Technical Service Bulletin 030413

Replacement UHF Preamplicifier Cover

This service bulletin concerns all Comark television transmitters utilizing the ADAPT ATSC exciter.

New perforated cover
P/N 37403358

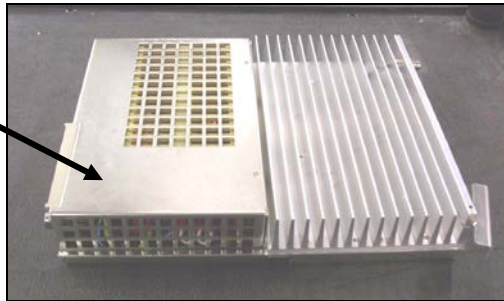
In an effort to increase the reliability of its products, Comark has designed a new cover (P/N 37403358) for the ADAPT Preamplicifier module. This new cover features additional perforations along the top and bottom edges to increase convection cooling air flow through the power supply section of the unit. The RF section of the preamplicifier is unaffected. No special tools or adjustments are required to install the replacement cover.

NOTE: For units with ARTESYN brand supply, leave internal cover in place. CHEROKEE brand supply has no internal cover.
